Environmental Impact Statement; Availability, etc.: Indian Point Nuclear Generating Unit Nos. 2 and 3, Buchanan, NY; License Renewal and Public Meeting

Entergy Nuclear Operations, Inc.; Indian Point Nuclear Generating Unit Nos. 2 and 3; Draft Supplemental Environmental Impact Statement; Request for Comment

NL-16-021

**Entergy Comments on Section 3.0 of the Draft Supplement  
(Revised SAMA Engineering Project Cost Estimates)**

Figure 3. Projected rainbow smelt larval abundance (blue bars) assuming reproductive failure of the 1995 year class. Orange dashed vertical line indicates historical timing of catastrophic decline.

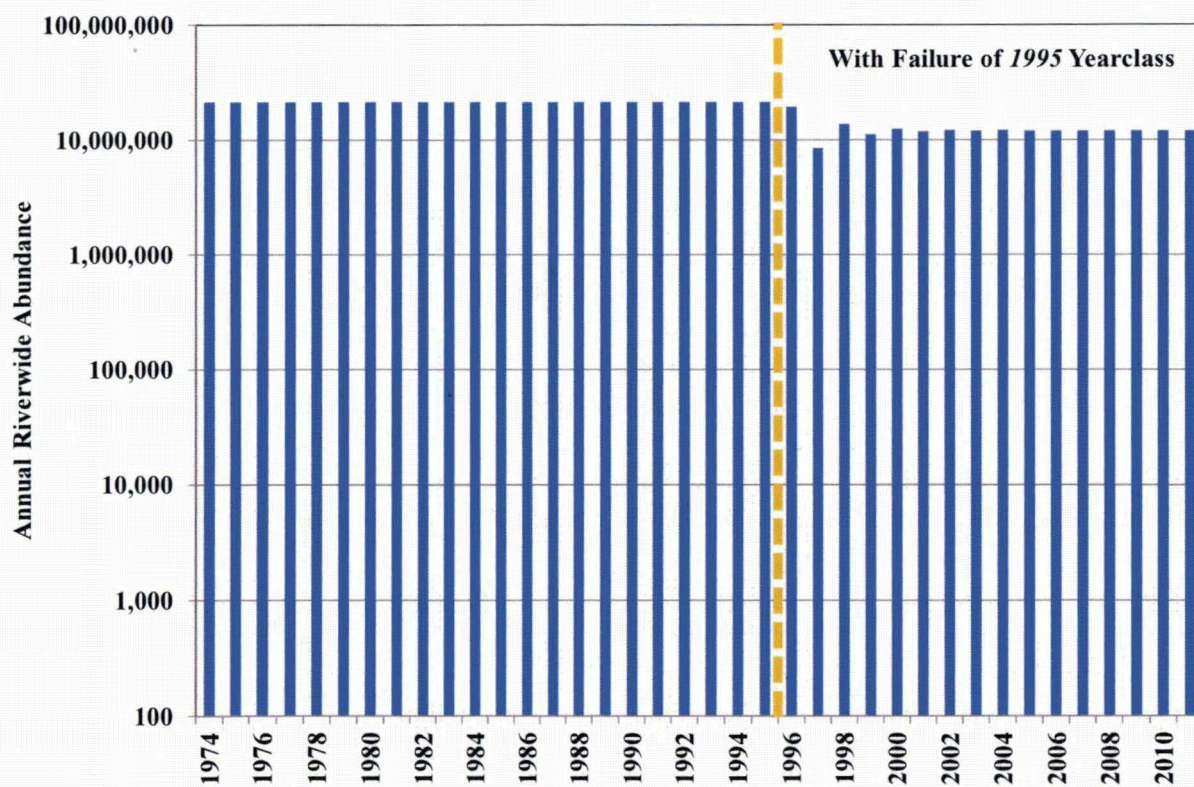
The first scenario was that only one year class, the 1995 year class, suffered reproductive failure. The projection for that scenario is depicted in Figure 3. The results indicate that if only the 1995 year class suffered reproductive failure, then the projected larval abundance starting in 1996 would have declined and stabilized to a level of about 12 million (down from 21 million on average prior to 1996).

Figure 4. Projected rainbow smelt larval abundance (blue bars) assuming reproductive failure of the 1992 through 1995 year classes. Orange dashed vertical line indicates historical timing of catastrophic decline.

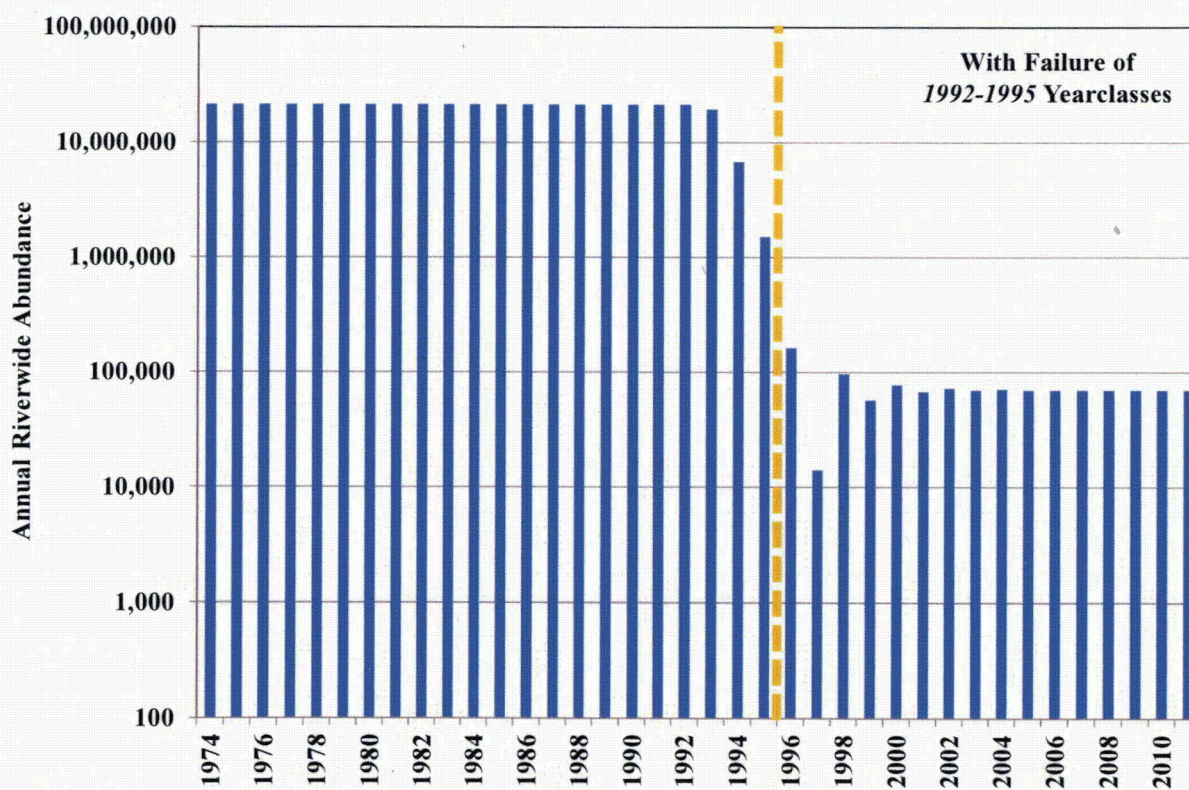
The second scenario was that four year classes, the 1992 through 1995 year classes, suffered reproductive failure. The projection for that scenario is depicted in Figure 4. The results indicate that if the 1992 through 1995 year classes all suffered reproductive failure, then the projected larval abundance starting in 1996 would have declined drastically and stabilized to a level of about 70 thousand.

Figure 5. Projected rainbow smelt larval abundance (blue bars) assuming reproductive failure of the 1991 through 1995 year classes. Orange dashed vertical line indicates historical timing of catastrophic decline.

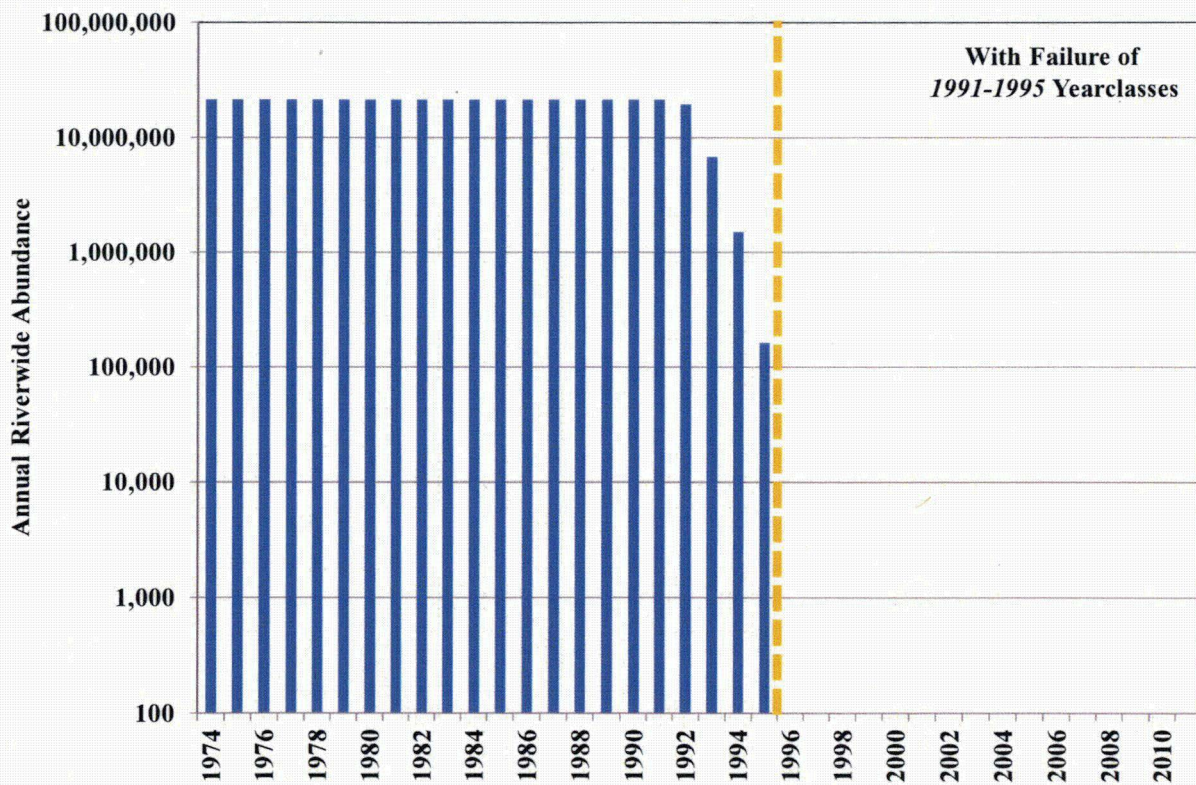
The third scenario was that five year classes, the 1991 through 1995 year classes, suffered reproductive failure. The projection for that scenario is depicted in Figure 5. The results indicate that if the 1991 through 1995 year classes all suffered reproductive failure, then the projected larval abundance would have dropped to zero starting in 1996.

Figure 6. Projected rainbow smelt larval abundance (blue bars) assuming reproductive failure of the 1990 through 1995 year classes. Orange dashed vertical line indicates historical timing of catastrophic decline.

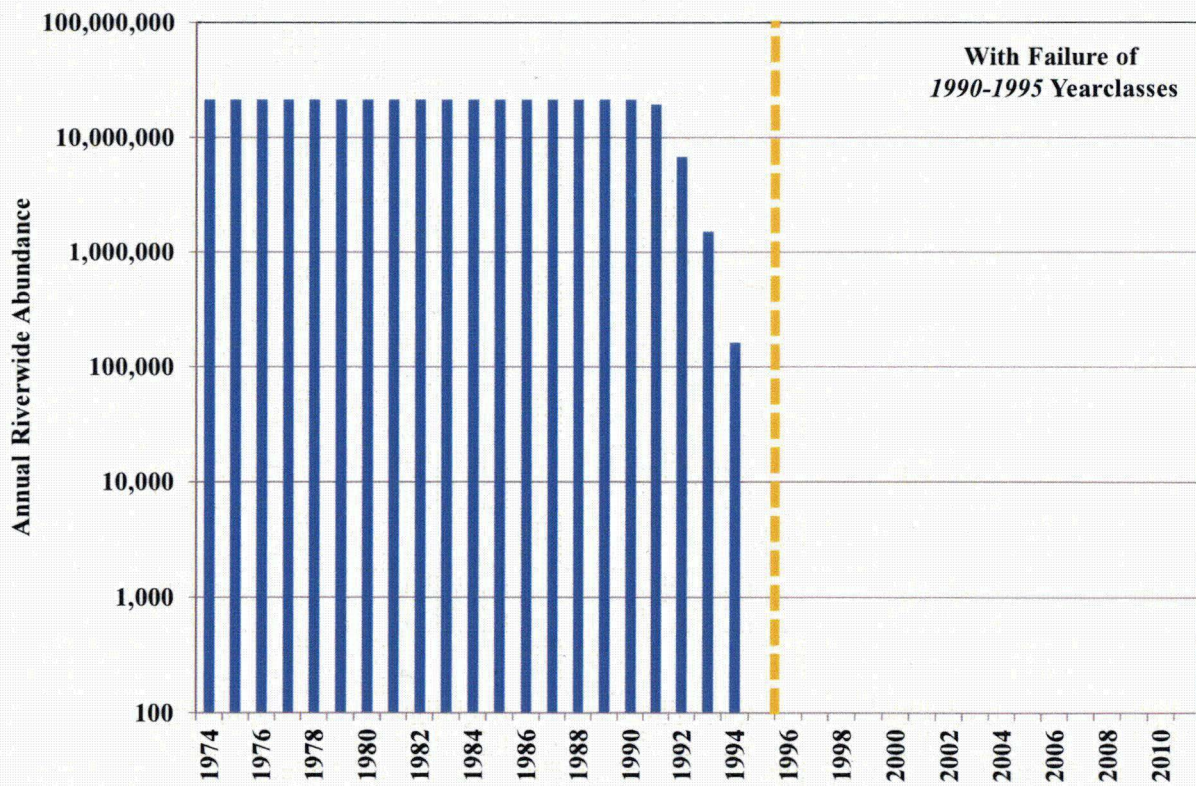
The third scenario was that six year classes, the 1990 through 1995 year classes, suffered reproductive failure. The projection for that scenario is depicted in Figure 6. The results indicate that if the 1990 through 1995 year classes all suffered reproductive failure, then the projected larval abundance would have dropped to zero starting in 1995.

Figure 5. Percent of Hudson River Rainbow Smelt (*Osmerus mordax*) observed with *Glugea hertwigi* infestation present by River Run (week) during 1991.

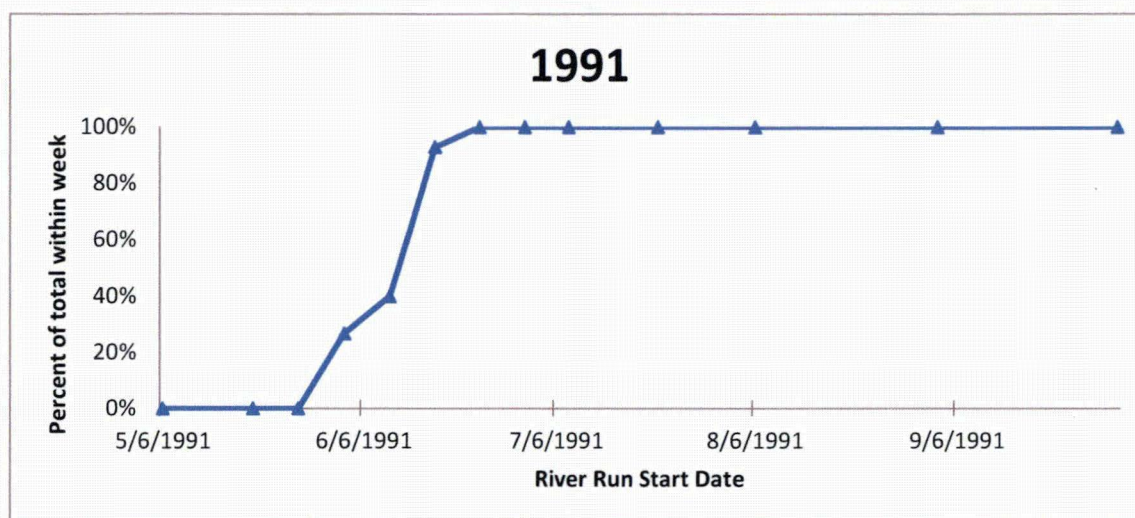
In both 1991 and 1993, a clear trend of increasing infestation over time (*i.e.*, over the course of the annual River Runs) and with increasing fish length was demonstrated.<sup>27</sup> As shown in Table 6 and Figure 5 of Appendix 2B, in 1991, fish from River Runs 4 through 8 (May) were predominantly free from infestation until River Run 9 (early June), at which time a transition appears to have taken place, with approximately 60% of fish found to be infested. Subsequently, in River Runs 10 through 19 (from mid-June on), almost all Rainbow Smelt were infested with *Glugea*.<sup>28</sup> The transition in mid-June from absence to presence of *Glugea* occurred within the 26-35 mm length classes<sup>29</sup> which corresponds with the transition from the PYSL life stage to YOY in Hudson River Rainbow Smelt. A similar pattern of infestation was

Figure 2 Annual CMR (%) for river herring at IPEC from 1974-1997, and maximum daily flow at Federal Dam between May 1 and June 15 of each year. The three years with highest CMR highlighted in yellow, and 4 selected years with low CMR and various levels of flow highlighted in blue.

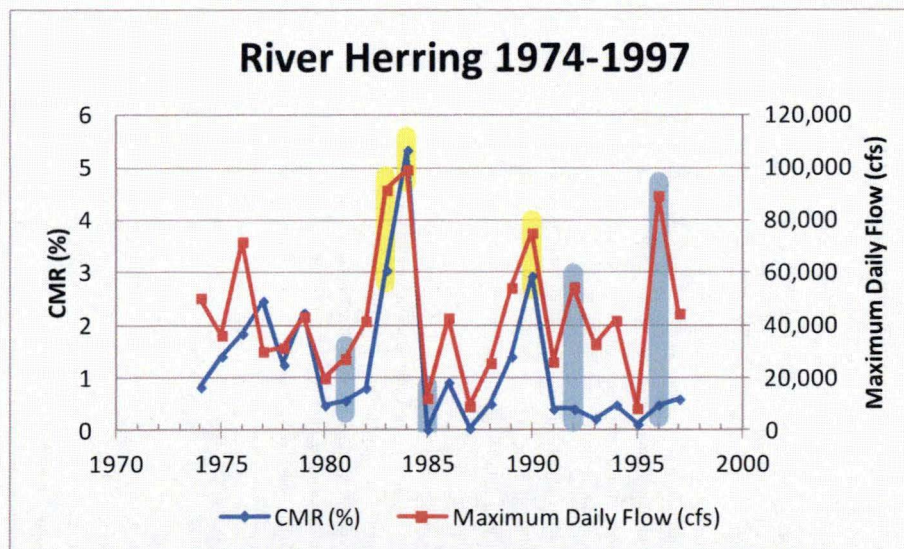
Examination of the CMR estimates from the DEIS, along with historical data on freshwater inflow to the estuary during the spawning season, indicates a strong relationship between the CMR and flow (Figure 2), which suggests the mechanism by which entrainment impacts at IPEC for this species are determined. Years with CMR of 3% or higher, e.g. 1983, 1984, 1990, experienced high freshwater inflow rates during the spawning and larval development period, May 1-June 15. Conversely, in years with low freshwater inflow rates, CMR was overwhelmingly below 1.5%, and often below 0.5%, e.g. 1985, 1987, and 1995. The spatial and temporal patterns of egg, larval,

Figure 9 Top – Relationship between maximum daily flow at the Federal Dam between May 1 and June 15 each year and river herring entrainment CMR at IPEC (1974-1997). Bottom – Cumulative frequency of maximum daily flow at the Federal Dam between May 1 and June 15 each year, (1947-2009)

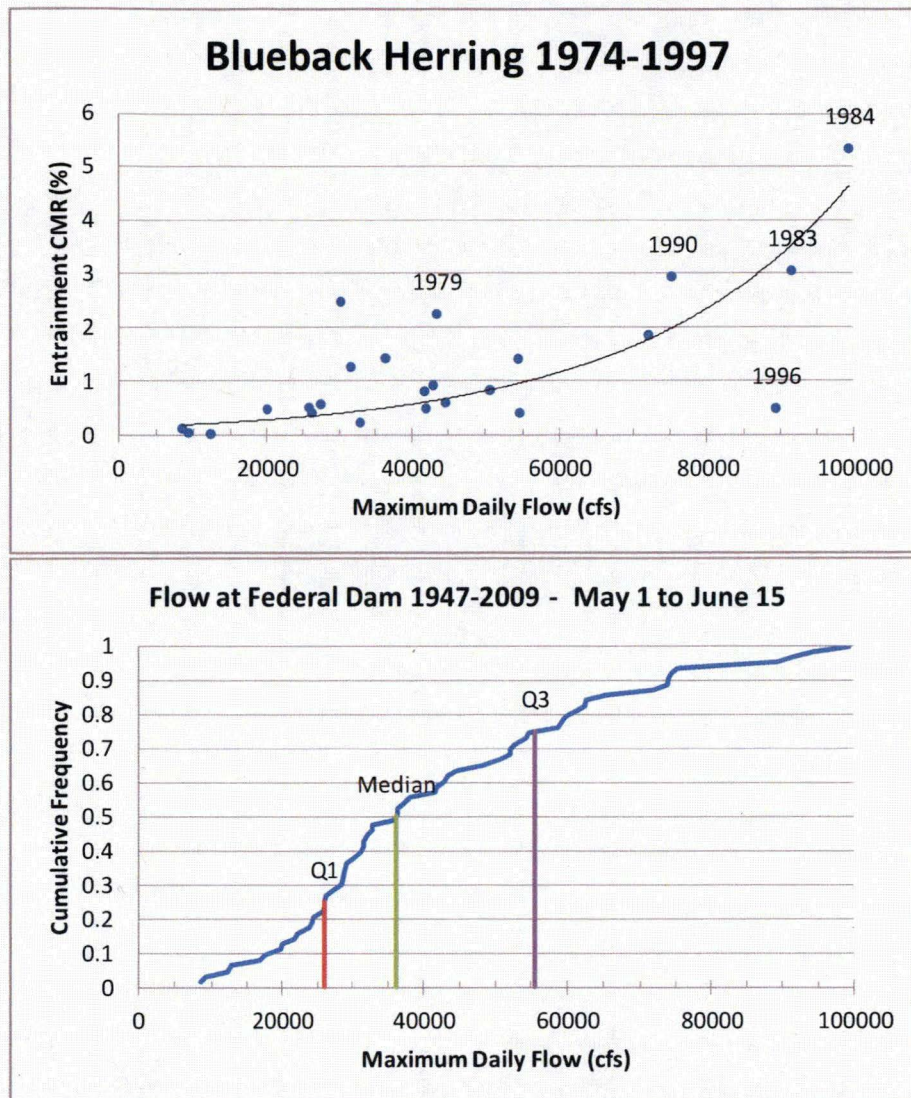
Hudson River Flow (in cfs) between May 1 and June 15 for the same span of years. As Figure 9 (top) shows, in 15 of the 24 years, the CMR value is below 1%. Indeed, the CMR estimate exceeds 3% in only two out of 24 years (1983 and 1984), and, in a third year (1990), the CMR approaches 3%. In all three of the years, the measured maximum daily flow exceeded 75,000 cfs, which corresponds to the 90<sup>th</sup> percentile of maximum flow measurements taken during this time period.<sup>56</sup> Thus, although high-flow events did not guarantee a high CMR estimate (as evidenced by the year 1996, in which a maximum flow of almost 90,000 cfs corresponded to a CMR of roughly 0.5%),<sup>57</sup> CMR values of roughly 3% or higher occurred *only* in infrequent years that had an unusually high flow events in the May 1 to June 15 timeframe.

<sup>56</sup> See Appendix 2C, Figure 9 (bottom).

Figure 4: Rainbow Smelt – Predicted Egg Entrainment Based on Riverwide Egg Abundance (Note: entrainment of eggs were only recorded in 1986 when entrainment sampling was conducted in March).

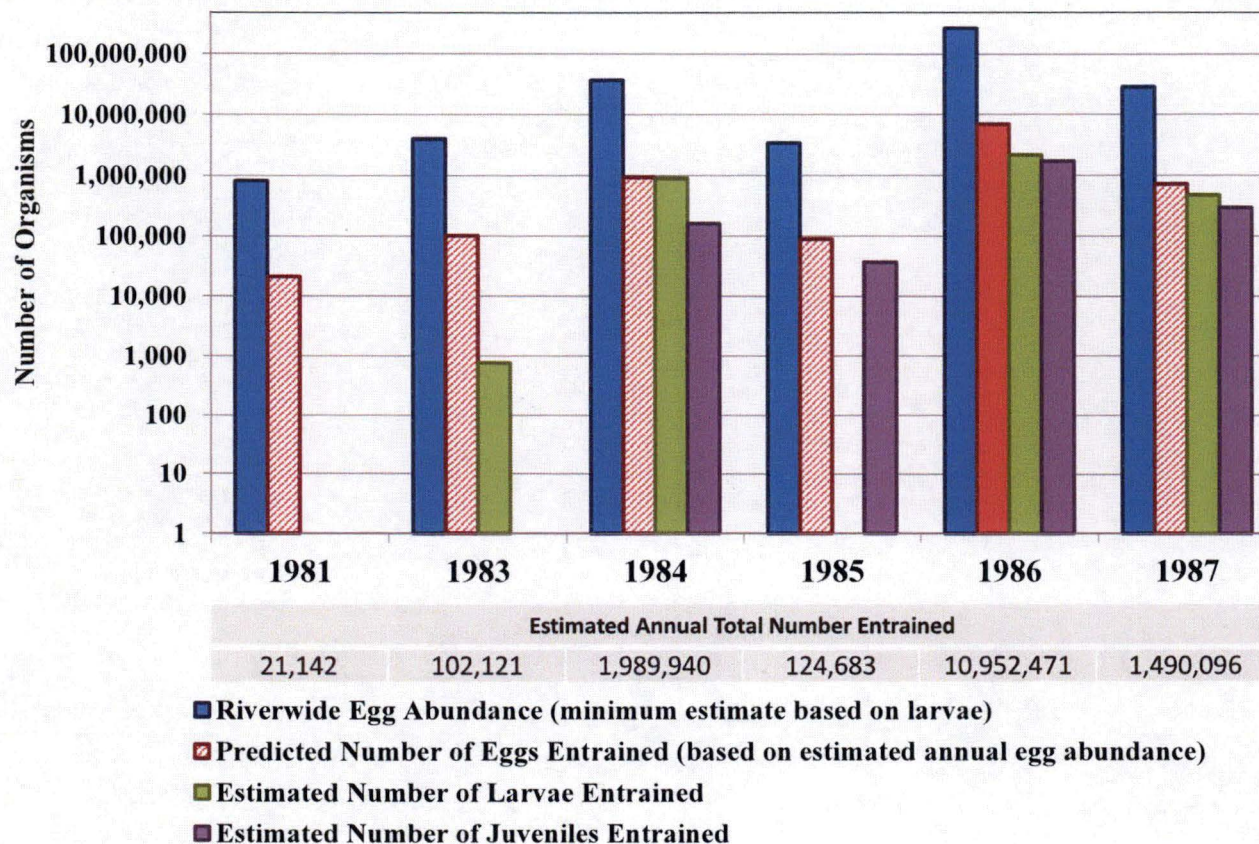
Figure 4 of Appendix 2D shows the predicted values of egg entrainment in these years (on a log<sub>10</sub> scale) based on application of the ratio of egg entrainment to minimum River-wide egg abundance in 1986 to the estimate of minimum River-wide egg abundance in each year. The estimated total number of eggs, larvae and juveniles entrained is presented numerically beneath each year. In Figure 4, the differences between the 1986 egg entrainment data (solid red bar) used by the NRC Staff and the year-specific predictions of egg entrainment (diagonal red-hashed bars) are readily apparent. These differences confirm that using the 1986 egg entrainment data for all six years is not a valid approach.

Figure 5: Rainbow Smelt – NRC Staff's Predicted Egg Entrainment (Note: entrainment of eggs was only recorded in 1986 when entrainment sampling was conducted in March)

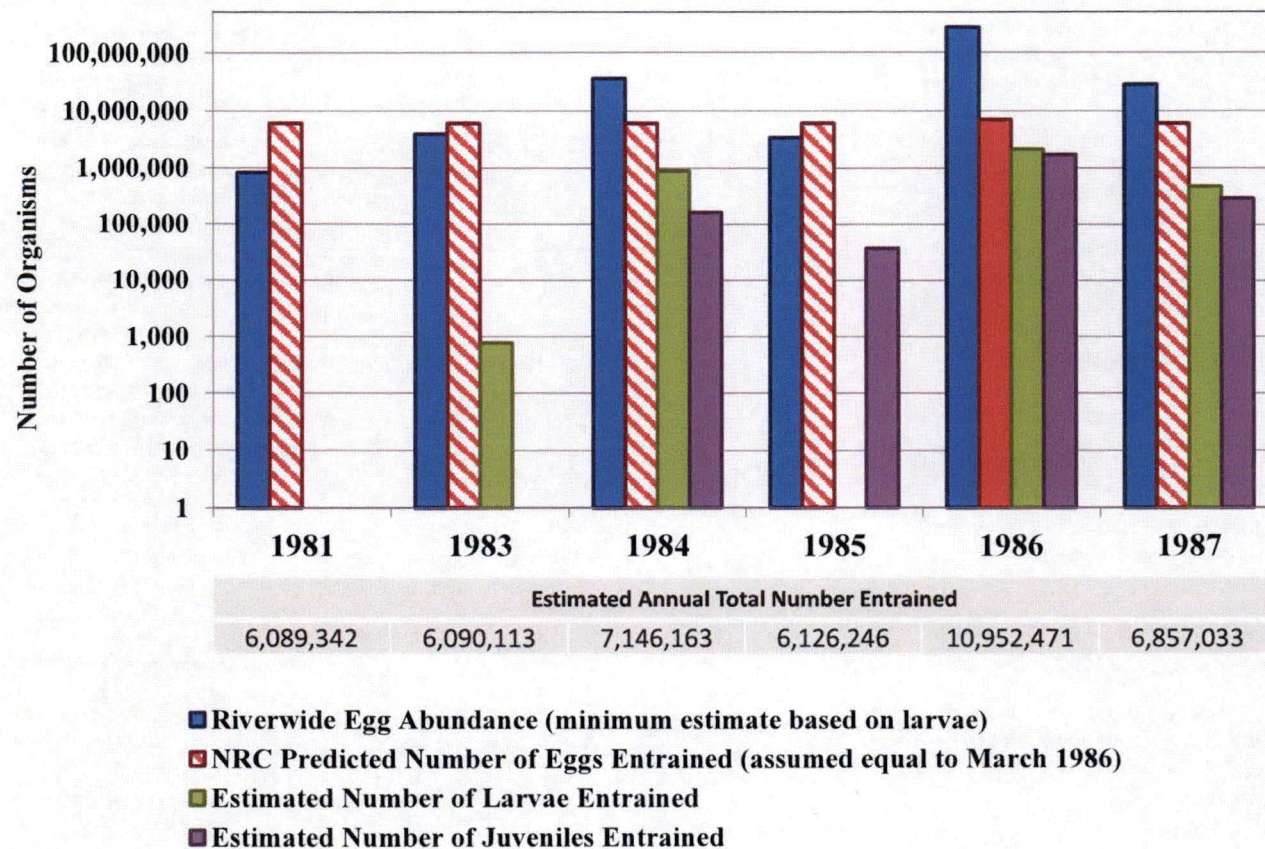
6. To calculate EMR for Rainbow Smelt, NRC Staff assumed the number of Rainbow Smelt eggs entrained in 1981, 1983, 1984, 1985 and 1987 was the same as the number entrained in 1986 (Figure 5).
